SUBJECT: Blurred copy problem on editor board

DATE: Dec.31,'93  
PAGE: 1 of 3PREPARED BY: T. Okajima  
CHECKED BY:

PDC-1E (Editor Board)

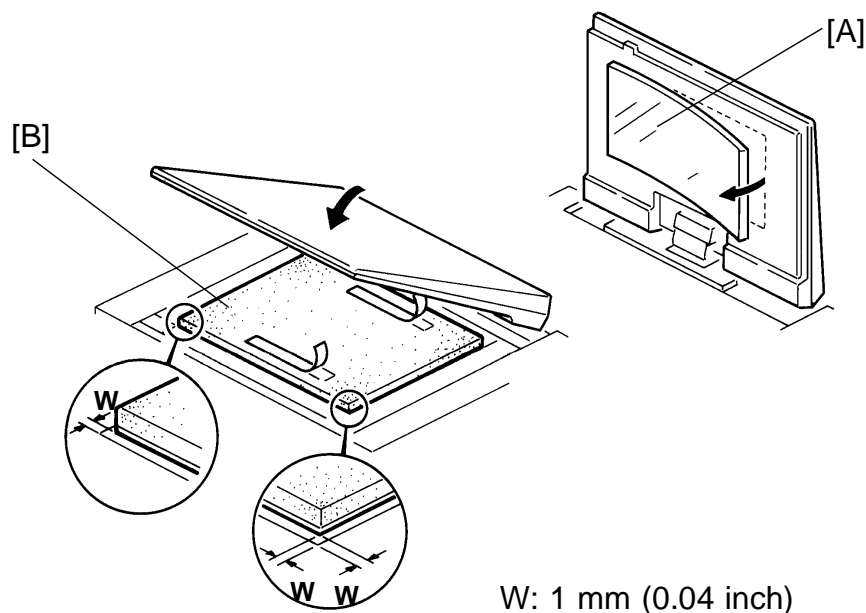
This problem occurs due to the deformed pressure pads (mirror surface). The deformed pad cannot press an original completely and there is a gap between the original and the exposure glass. The focal depth of the scanner is only 0.25mm. If this gap is 0.25mm or wider, an image in that part will be blurred.

The present pressure pad is made of polypropylen, which starts to deform from about 79°C (174.2°F) or higher. We suppose that the editor board suffers temperatures of 79°C or higher during transportation.

The pressure pad of the platen cover for the PDC-1E is the same as that of the editor board. However, the pressure pad of the platen cover does not have the deformation problem because during transportation, the pressure pad is on the exposure glass which is flat. Even under high temperature (higher than 79°C) it will not be deformed by the exposure glass.

We have changed the material of the pressure pad from polypropylen to polycarbonate which does not deform at temperatures under 130°C (266°F).

Old Part Number	New Part Number	Description
A0491576	<b>A0921594</b> This part number will be available as a service part in February 1994.	Original Pressure Pad
